Serial Number 09/986,030

AMENDMENTS TO DRAWINGS

FIG. 8

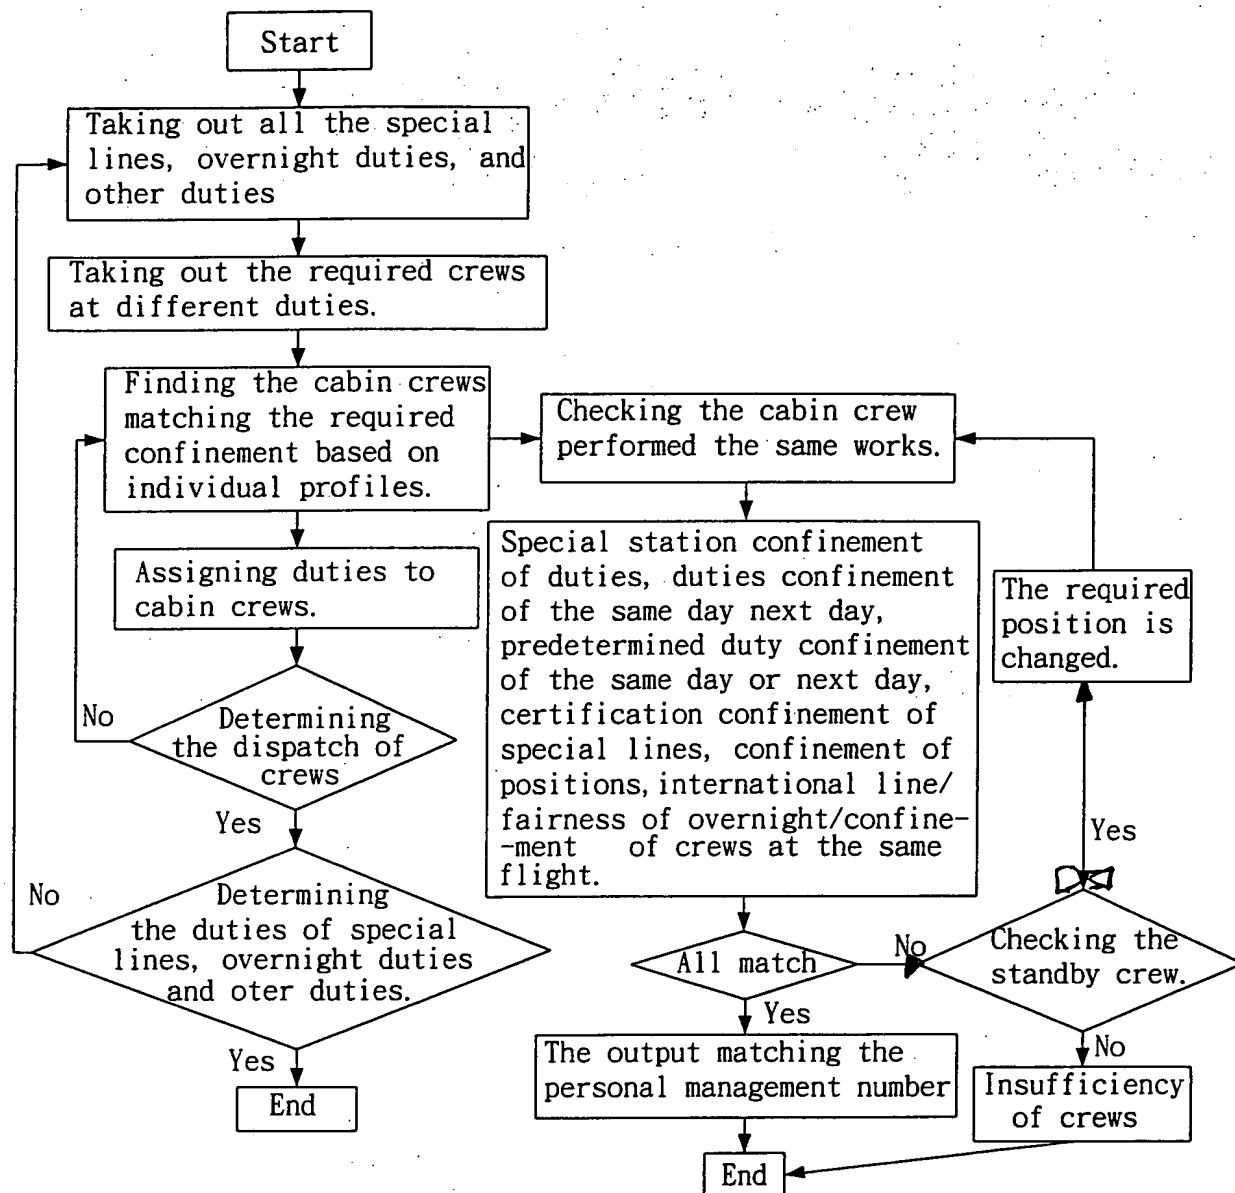
Please amend Fig. 8 by adding an arrowhead to the line extending to the right of the “All match” block, and by reversing the arrow from the “Checking the standby crew” block to the “The required position is changed” block, as marked in red on the copy of Fig. 8 attached hereto for approval by the Examiner.
